**BALTIMORE COUNTY, MARYLAND
DEPARTMENT OF PUBLIC WORKS AND TRANSPORTATION
DIVISION OF CONSTRUCTION CONTRACTS ADMINISTRATION
111 WEST CHESAPEAKE AVENUE
TOWSON, MARYLAND 21204**

Contract No. 25010 PO0
Project No's. 107011861
Jacksonville Senior Center Expansion -
3605 Sweet Air Road, Phoenix, Maryland 21131
Phoenix – District 10c3

ADDENDUM NO. 1

DATE: 8/8/2025

1 SD: I-211 to M-209 SCALES: HORIZ. 1" = 30' VERT. 1" = 5'

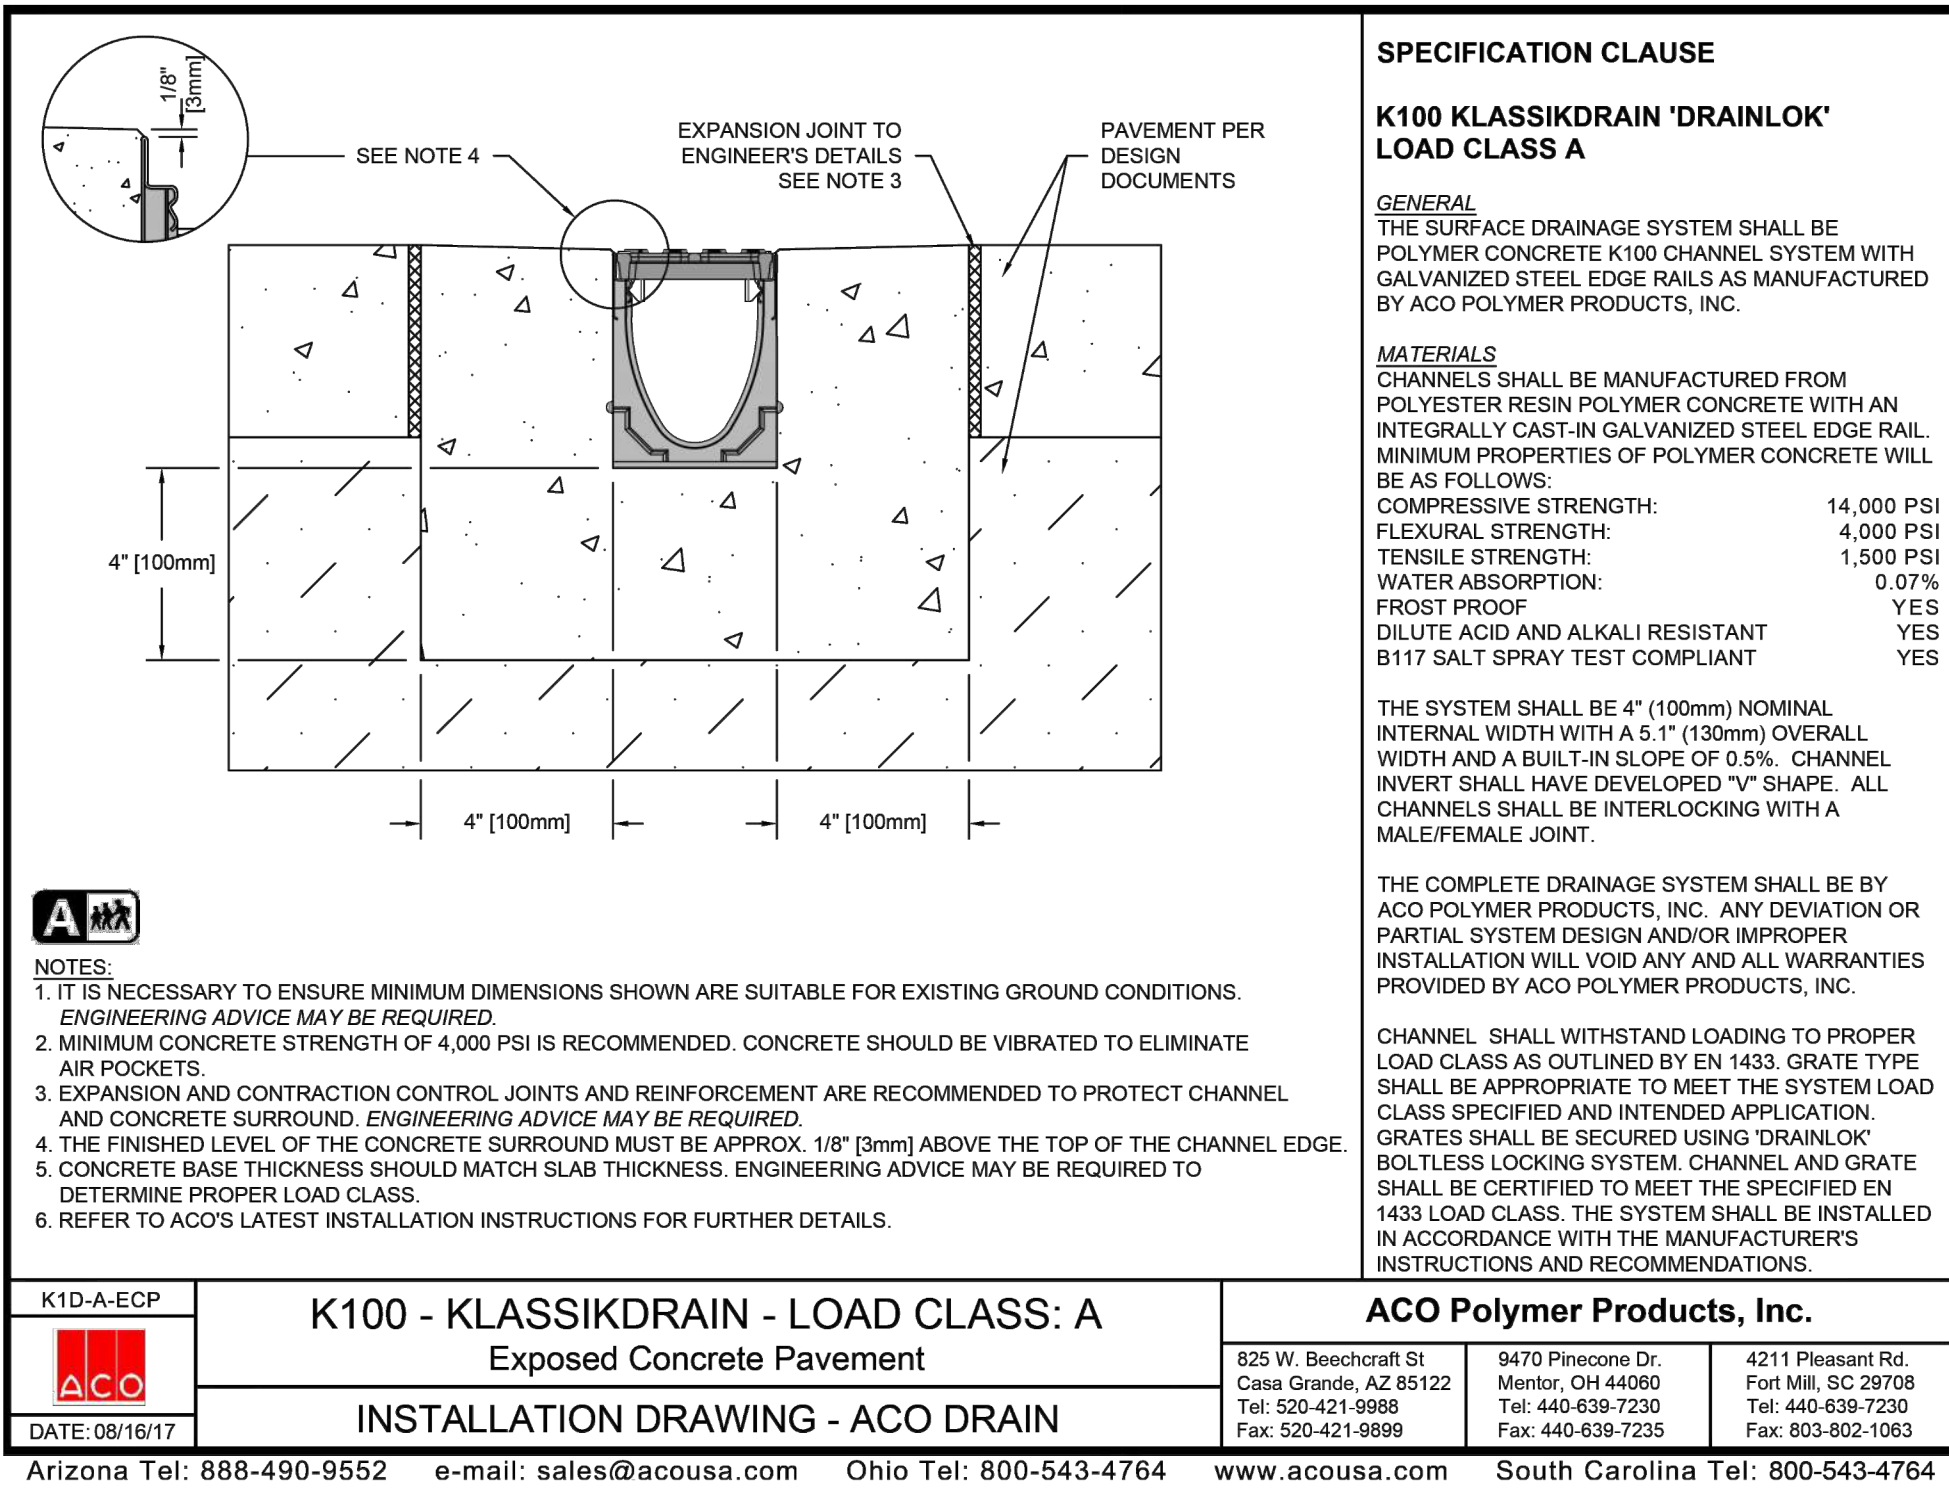
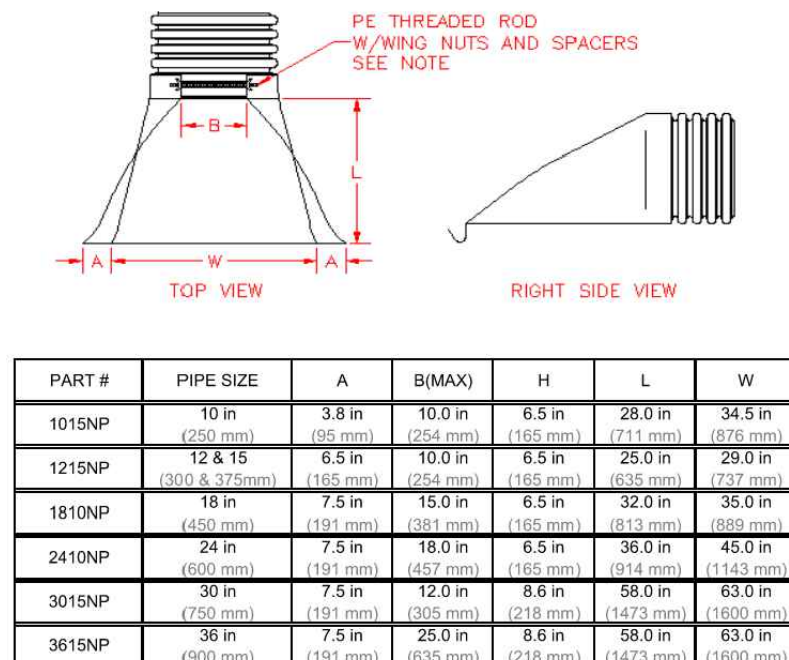
15	<p>On sheet C151 there is what appears to be a manhole designated as M - 209 however M -209 is not listed on the Storm Drain Structure Table found on sheet C302. Please provide specifications for M - 209.</p>	<p>M-209 has been added to the structure schedule. See revised sheet C302.</p>
16	<p>The Septic Tank Schedule on sheet SW201 shows an inlet elevation of 570 and outlet elevation of 570.17 for septic tank #2. The septic system profile on SW203 represents a downward slope whereas the schedule's elevations are higher on the outlet than inlet, please confirm correct elevations for septic tank #2.</p>	<p>Follow the tank's schedule. Profile has been adjusted to reflect these changes and provide the appropriate callouts. See revised sheet SW203</p>
17	<p>We visited the site and observed 2, 3" Diameter Green pipes stubbing out of the ground that appear to be a septic vent or cleanout access. There is no representation of any Septic systems or piping of any kind in the wooded area to be cleared and developed. Is this a decommissioned septic system from the previous building (foundation ruins present). Please provide clarification/identification of any existing underground utilities present in areas to be developed/improved.</p>	<p>Green PVC pipes were installed by the geotechnical engineer for infiltration testing and may not have been removed. Please confirm if location of observed pipes corresponds with SWM test pits shown on the Boring Location Plan in the geotech report.</p>
